Access Compliance Report

Public Rights-of-Way

(Curb Ramps)

Intersection ID: 9027	Main Street: ROZZELLES_FERRY_RD	Cross Street: NORWOOD_DR	Location: S
ADA ID: 05B0A52E6273	Ramp Type: Perp	Initial Pass/Fail: Fail	Overall Compliance: No
Severity Score: 8.75			
Codes/Mitigation Info/Possible Solution		Field Measurements/Component Compliance

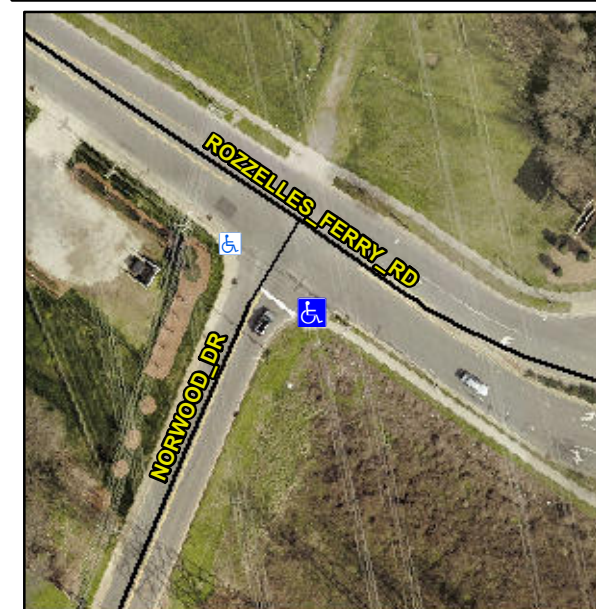
Not Found, R304.5.1

Compliance	Description	Data	Compliance	Description	Data
N/A	Ramp Length (in)	94.5	Yes	Ramp Slope (%)	8.1
No	Ramp Width (in)	47.5	Yes	Ramp XSlope (%)	1.3
N/A	Flare Type LT	N/A	N/A	Flare Type RT	N/A
N/A	Flare Slope LT (%)	N/A	N/A	Flare Slope RT (%)	N/A
N/A	Flare Traversable LT?	N/A	N/A	Flare Traversable RT?	N/A
N/A	Landing Length (in)	N/A	N/A	DWS Provided?	N/A
N/A	Landing Width (in)	N/A	N/A	DWS Contrast?	N/A
N/A	Landing Slope (%)	N/A	N/A	DWS Length (in)	N/A
N/A	Landing X Slope (%)	N/A	N/A	DWS Full Width?	N/A
N/A	Landing Curb? (Y/N)	N/A	N/A	DWS Offset (in)	N/A
N/A	Shared Landing?	N/A			
N/A	Gutter Ponding?	N/A	N/A	Gutter Slope (%)	N/A
N/A	Gutter Lip Ht (in)	N/A	N/A	Gutter X Slope (%)	N/A
N/A	Painted X Walk1?	No	N/A	Painted X Walk2?	N/A
	X Walk 1 Direction	To NW		X Walk 2 Direction	N/A
N/A	X Walk 1 Width (in)	N/A	N/A	X Walk 2 Width (in)	N/A
	X Walk 1 Slope (%)	5.8		X Walk 2 Slope (%)	N/A
	X Walk 1 X Slope (%)	3.1		X Walk 2 X Slope (%)	N/A

Remove & Replace Entire Ramp.
